**STAFF REPORT  
WEST ALLIS PLAN COMMISSION  
Wednesday, December 14, 2023  
5:00 PM**

- 3A. Conditional Use Permit for Bars & Recreation, a proposed Recreation (indoor) and Tavern use, at 6325 W. National Ave.
- 3B. Site, Landscaping, and Architectural Design Review for Bars & Recreation, a proposed Recreation (indoor) and Tavern use, at 6325 W. National Ave. (Tax Key No. 454-0122-001)

# BARS & RECREATION - INTERIOR ALTERATION

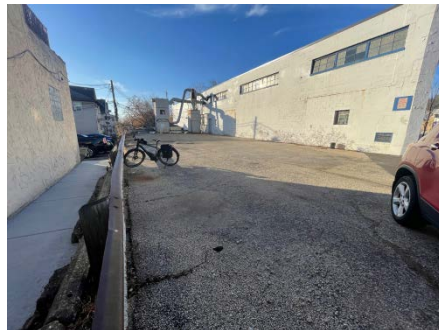
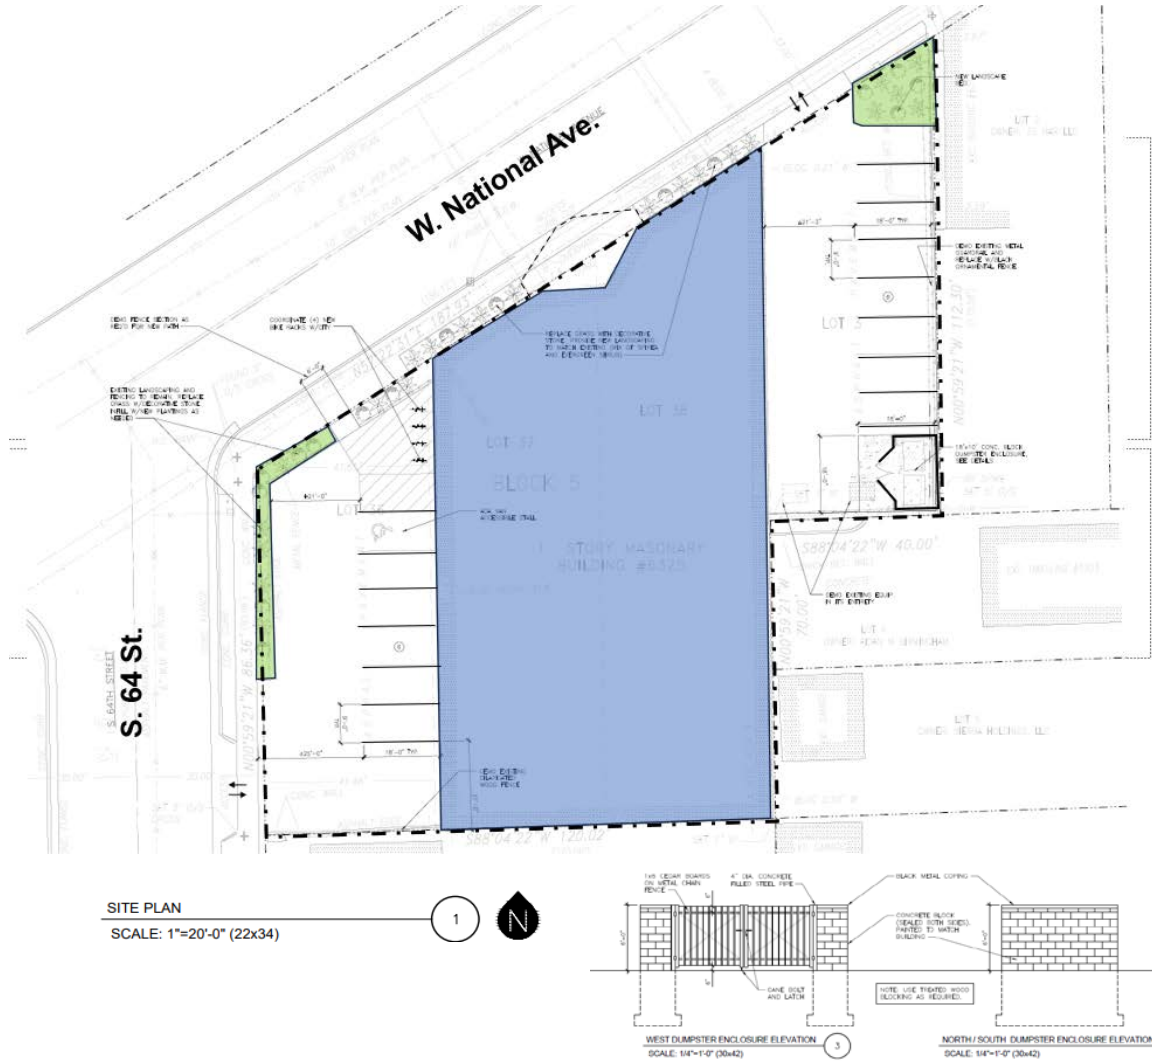
East parking lot - The existing guardrail along the east side of the property will be removed, and a new decorative black metal fence will be installed around the east and south perimeter of the parking lot. A new landscaping bed will also be installed at the NE corner of the property. Staff is recommending that the landscaping plan include a schedule to identify species and quantity on site.

West parking lot – The existing west parking lot features a black ornamental fence and landscaping. These features will remain but be modified to infill and freshen up the landscaping, and also to remove a section of fencing to allow for direct access to/from the front door of the building to the parking lot. An

old section of fencing and pipe railing on the very south end of the parking lot will be removed. On the north end of the parking lot near W. National Ave. 4 bike racks will be installed and also a new ADA parking space with accessible aisle.

1. Common Council approval of the Conditional Use Permit (Public Hearing December 12, 2023).
2. Revised site, landscaping, and architectural plans being submitted to the Planning and Zoning Office to show the following: (a) new windows that fit existing openings on north and west facades; (b) evaluate structural integrity of retaining wall and adjacent parking lot, abate any rodent issues, and repair/replace as necessary; (c) new metal fence details being provided; (d) site and landscaping plan revisions to accurately show W. National Ave. streetscape as built; (e) landscaping plan to include a schedule to identify species and quantity on site;.
3. Signage and exterior lighting plans being submitted to the Planning and Zoning Office for permit design review.

**Architectural**

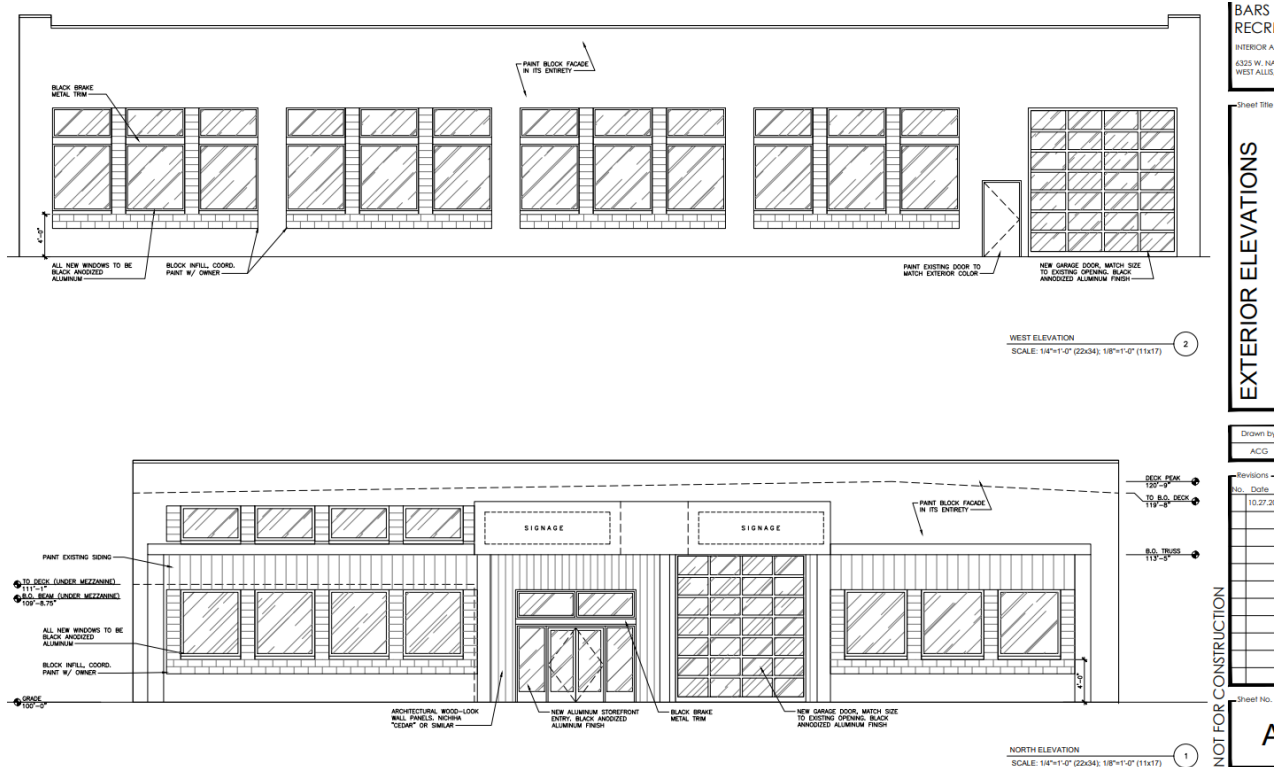
- As proposed in the plan submittal, the existing window openings will be reduced in size to accommodate the new window systems. Staff isn't opposed to the removal of existing glass block but is recommending the applicant install a new window that fits the existing opening vs. cement block infill of openings (and smaller windows) on north and west facades. Our preference is to preserve existing opening size with a similar but more modern/energy efficient "shop window."
